#### HISTORIC AND DESIGN REVIEW COMMISSION

# July 06, 2016 Agenda Item No: 8

HDRC CASE NO:	2016-246
ADDRESS:	114 CAMP ST (Unit 401)
LEGAL DESCRIPTION:	NCB 2561 BLK 4 LOT 5 THRU 11 SAVE & EXCEPT IRR 95 SQ FEET OF
	LOT 11 & W 7 FT OF ALLEY **MASTERFILE CAMP STREET RESIDENCES
	CONDOMINIUMS
ZONING:	IDZ HS
CITY COUNCIL DIST.:	1
LANDMARK:	Tobin Survey Co
APPLICANT:	Jim Poteet/Poteet Architects, LP
<b>OWNER:</b>	Griffith Park, LLC
TYPE OF WORK:	Removal of 3 windows to create an open air porch

# **EXTERIOR ELEVATION: EAST**

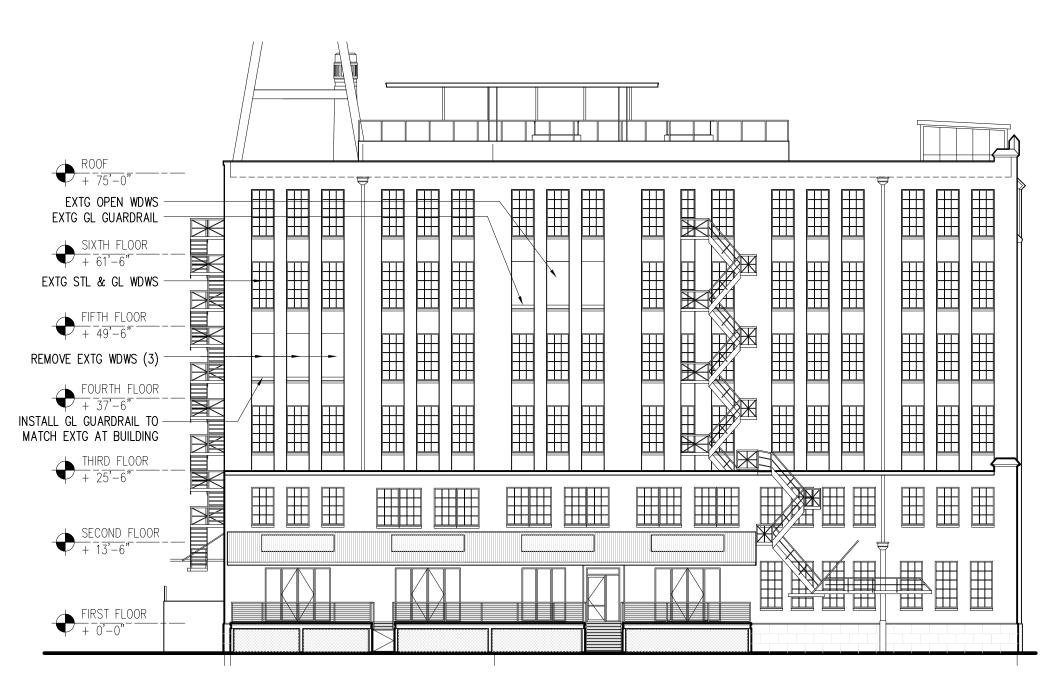
- a. The applicant has proposed to remove six (6) original glass and steel windows, without altering the size or shape of the opening, from the southeast corner of the fourth floor of 114 Camp to create an open air sitting area. The applicant has proposed to remove three (3) windows on the east façade and three (3) windows on the south façade. According to the Guidelines for Exterior Maintenance and Alterations, existing window and door openings should be preserved. Staff finds the applicant's request consistent with the Guidelines for Exterior Maintenance and Alterations 6.A.i. given that the original openings will be neither modified nor enclosed. The applicant has noted that the windows that are to be removed will be maintained and stored on site for potential reinstallation in the future.

- b. Staff performed a site visit on June 23, 2016, and found that the proposed window removal will not negatively impact the architectural integrity of the structure.

Staff recommends approval as submitted based on findings a and b with the stipulation that the applicant store the removed windows on site for future use.

114 CAMPSTREET, UNIT 401	
DATE: JUNE 27, 2016	VIEW
POTEET ARCHITECTS	PAGE 1 OF 1

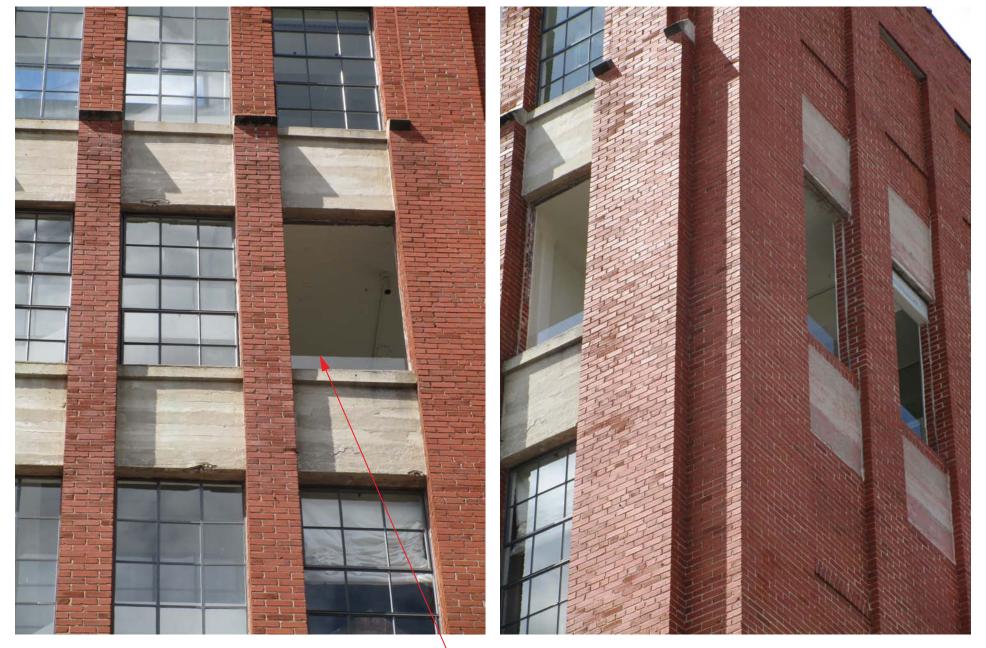
- c. The applicant has noted that a glass guardrail will be installed in each window opening to be 42" above the finished floor. The applicant has noted that these guardrails will match existing guardrails found on other window openings. Staff finds the applicant's proposed material and installation appropriate.

— TOP OF GLASS IS 42" AFF
